# FRIENDS OF THE EEL RIVER

**Re: COMMENTS on Application by Pacific Gas and Electric for Temporary Variance Of Minimum Flow Requirement, Potter Valley Project (FERC Project No. 77-275); MOTION TO INTERVENE.**

**Re: Comments on Application by Pacific Gas and Electric for Temporary Variance of Minimum Flow Requirement, Potter Valley Project (FERC Project No. 77-275)**

*Figure 1. Estimated unimpaired spring-through-summer recession hydrographs at Van Arsdale from WY1977 to WY2011.*

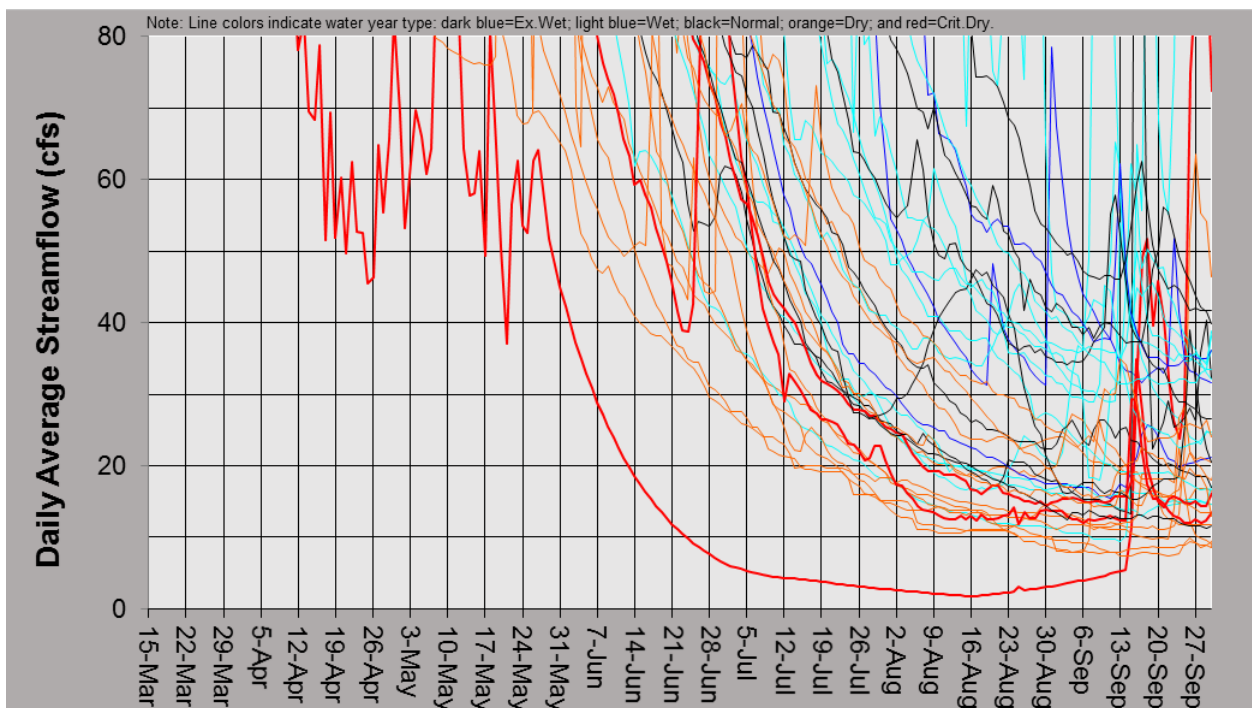
For example, a Dry SF = 9 cfs prescribed to 'replace' the two lowest orange-coded, Dry recession limbs **from August 23 to September 27** in Figure 1 would not have adverse impacts, whereas prescribing a Dry SF = 9 cfs to replace the two greatest orange-coded Dry recession limbs **in July and August** would have highly adverse impacts on the level of juvenile salmonid rearing success once attainable with the unimpaired recession hydrographs. Similarly, a Wet SF

= 15 cfs would have highly adverse impacts if/when prescribed for most blue-coded recession limbs, when unimpaired baseflows in late-summer were considerably greater.

PG&E does not provide a habitat analysis for the flow variance request, computing only a single percentage habitat reduction but not scientifically justifying why the 12.4% juvenile steelhead habitat reduction should be considered insignificant. The relevant statistic is the percent decline in AHA, not the weighted habitat abundance relative to 100% AHA (i.e., peak AHA). Figure 1 shows that 14 cfs, or 12 cfs, may be the ‘natural flow condition’ in only the driest WYs.
